Hamilton Estates
Conditional Use Plan

Re: Hamilton Estates - Conditional Use Plan – Landscape review.

The review included sheets EX-1, LP-1, LP-2, LI -1, LI-2 prepared by the applicant's consultant, Glackin Thomas Panzak, Inc.

Filed review and Notes.

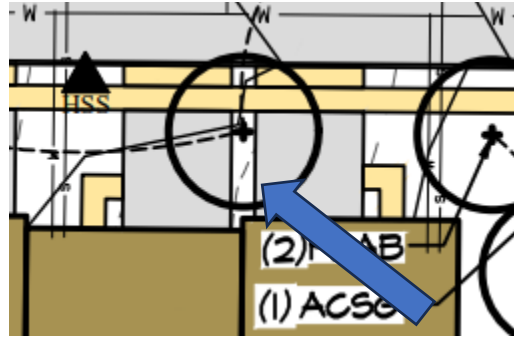
There is a total of 223 trees to be removed based on the plan set removal sheets. The table block key denotes that the dark shaded trees represent 223 trees TBR. The lightly shaded areas denotes trees in decline, dead, poor or decay and represent 109 trees that will not be compensated for. Based on these figures and a count of the trees, the proposed table block is incorrect. 223 trees to be removed (- 109 trees that are not be compensated for) = 114 trees to be compensated for based on my field review. The plan is compensating for 121 trees. Applicant to revise removal counts.
